ADDENDUM NO. 1- QUESTIONS AND ANSWERS IFB-GC-FG-01-24 FAIRGROUNDS RESTROOM

60.) Restroom/Toilet Accessories

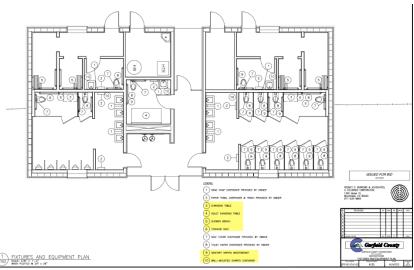
a. Please provide a spec brand/model (American Specialties) for the toilet accessories to be provided/installed by the contractor

A list is as follows:

Plumbing fixtures -Toilets	Afwall® Millennium® 1.1 – 1.6 gpf (4.2 – 6.0 Lpf) Top Spud
Figuriality fixtures -10ffets	Elongated Wall-Hung EverClean® Bowl 3351101.020
Plumbing fixtures MACs (Verify count	
with Vendor) Only for use with	
Sensored Flushvalves	
Plumbing fixtures Hardwire Kits (Verify	
Count with Vendor) Only for use with	
Sensored Flushvalves	
Plumbing fixtures toilet flushvalves	Ultima™ Manual Toilet Flush Valve, Diaphragm-Type, 1.1
Fruitioning fixtures toffet flustivatives	gpf/4.2 Lpf 6147161
plumbing fixtures mop sink	Florwell™ Floor-Mount Cast Iron Service Sink 7741000.020
	Maybrook® 0.125 – 1.0 gpf (0.47 – 3.8 Lpf) Top Spud
plumbing fixtures urinals	Urinal 6581001.020
	Washbrook Urinal System with Manual Piston Flush
plumbing fixtures urinal flushvalves	Valve, 0.5 6590501
	,
Plumbing fixtures soap dispenser	American Standard 777B100
	NextGen™ Selectronic® Touchless Faucet, Base Model
	With SmarTherm Safety Shut-Off + ADM, 1.5 gpm/5.7 Lpm

Plumbing fixtures faucets	775b315
Plumbing fixtures hand washing Sink	Murrow Wall-Hung Ever Clean sink 0955123ec.020
	Top Brac Wall-Mount Service Sink w/ Vacuum Breaker
Faucet for Mop Sink	Spout 8344012.002
Plumbing Shroud for sinks	Plumbing Shroud 0062000
	Foundation Chambin Chaties 400007 Cha Child Ch
	Foundations Changing Station: 100SSE-SM, Stainless Steel,
Special Needs Changing Table	23 1/8in x 64 3/4 in x 4 in, Horizontal Item 39F740, Mfr. Model 100SSE-SM (Grainger)
Special recess changing rable	INIQUE 100331-3141 (Graniger)
	Foundations Baby Wall Seat: 5806086, Plastic/Steel, 15
	1/2 x 12 in x 4 in, ADA Compliant, White, Item 35MG25,
FOUNDATIONS Baby Wall Seat	Mfr Model 5806086 (Grainger)
	Foundations Changing Station: 100-EH-BP, Plastic, 15 3/8
	in x 34 1/4 in x 4 in, Flush Mount, Gray Item 39F735, Mfr.
FOUNDATIONS Changing Station	Model 100-EH-BP

Commercial Shower System Trim Kit for Flash Rough
Shower Trim Kit	Shower Valve Model TU662SG.213
	American Standard Rough Valves In-Wall Two-Way
Rough Valves - Diverters for Showers	Diverter Valves R422
	KETCHAM Washroom Mirror: Rectangluar, 36 in x 18 in x
Ketchum Washroom Mirror 18x30	1/2in, Wall, Glass, Rust Resistant Item 14C574, Model TPM-1836 (Grainger)
Sharps Containers & Wall brackets	GRAINGER
Towel Hooks	GRAINGER
	Tough Guy Sanitary Napkin Receptacle: Wall or Free- Standing, 5 1/4 in Wd, 10 in Ht, 5 3/4 in DP Item 2NXW1
Hospeco Sanitary Napkin Wastebasket	Mfr. Model 2NXW1
18" grab bars	Grainger
42" grab bars	Grainger
36" grab bars	Grainger
paper towel dispensers	Provided by owner
toilet paper dispensers	Provided by owner
sanitary napkin dispensers	Provided by owner
seat cover dispensers	Provided by owner
Toilet Stall Partitions	Hadrian
Drinking Fountain/Water Bottle Filling	Non-Refrigerated Water Bottle Filling station and drinking fountain EZWS-EDFP217K
